Response to Environmental Permitting Regulations 2016 Schedule 5 Notice, Issued 17/10/2018

Application number: PAN-002429

Document Number: WN0908-HZPSP-MSB-CLA-00001

Response to Environmental Permitting Regulations 2016 Schedule 5 Notice	Document No.	Revision:	1.0
	WN0908-HZPSP-MSB-CLA-00001	Issue date:	13/11/2018

Figure 1 Reactor building profile

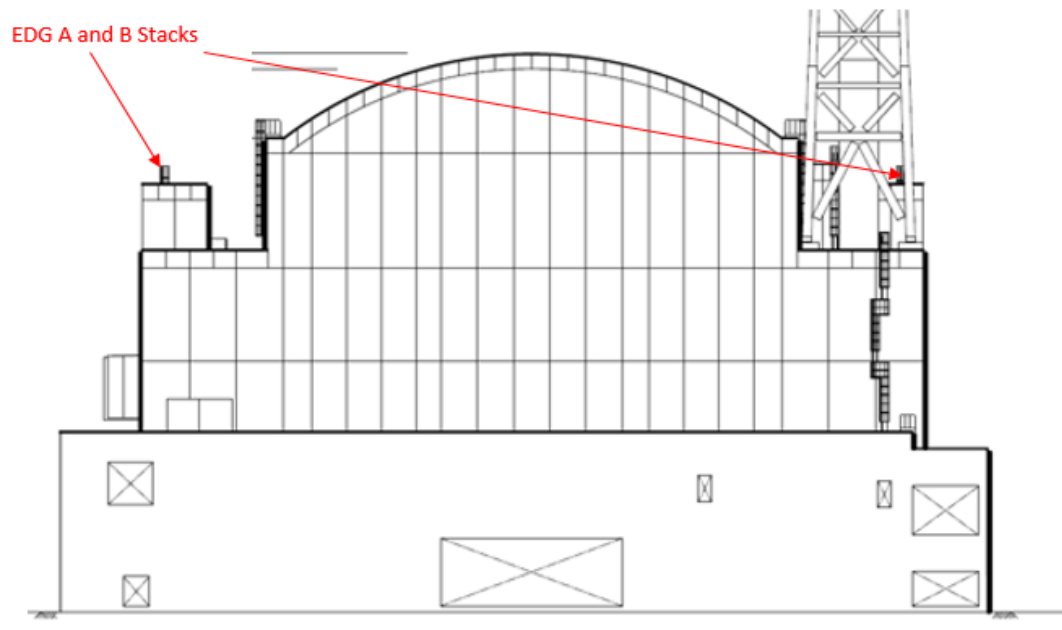
NRW requirement 1: Section 2.3, p9. "EDG A and EDG B have their stacks routed up the sides of the reactor building, the first configuration assumes the stacks are 3m above the reactor building's parapet, which in turn is 7m lower than the reactor building dome." Please provide evidence that this configuration represents a worst-case scenario in terms of building downwash effects.

NRW requirement 5: Table 2.4, p20. Please state how many building roofs associated with stack emissions are not flat but modelled as flat roofs. Please provide detailed information of building roof features (i.e., dome, slope) and any sensitivity analysis that has been undertaken to consider the impact of these roof features in terms of building downwash effect.

NRW requirement 8: Table 2.2, p10. Please provide the detailed information of the shape and dome features on the roof of 1-101 and 2-101 buildings. Please provide any sensitive analyses undertaken in terms of the selection of roof height (from parapet to apex), selection of main buildings (i.e., 49 m buildings). Please provide evidence that the proposed approach (moving stack away from the wall) would not affect plume-trapping in the building downwash. Also, please provide evidence that the selected scenario (i.e. main building, building height and moving stack) has reflected a worst-case prediction in terms of building downwash effect.

The reactor buildings (1-101 and 2-101) are the only modelled buildings which do not have flat roofs. The reactor building is a tiered building arrangement with a domed roof. EDGs A and B are installed in buildings immediately adjacent to the reactor building. However, due to this proximity, it is possible to route their stacks up the side of the reactor building, using the reactor building walls as support. It is not possible to do so for Unit 1 and Unit 2 EDG C since these EDGs are installed in a building which is a greater distance from the reactor building.

The stacks for EDGs A and B discharge 3 m above a parapet on the second tier of the reactor building, resulting in the stacks discharging approximately 4 m below the apex of the reactor dome (the top of the parapet is 7 m below the apex of the dome). Figure 1 visually depicts the tiered structure of the reactor building and the location of the stacks for EDGs A and B.
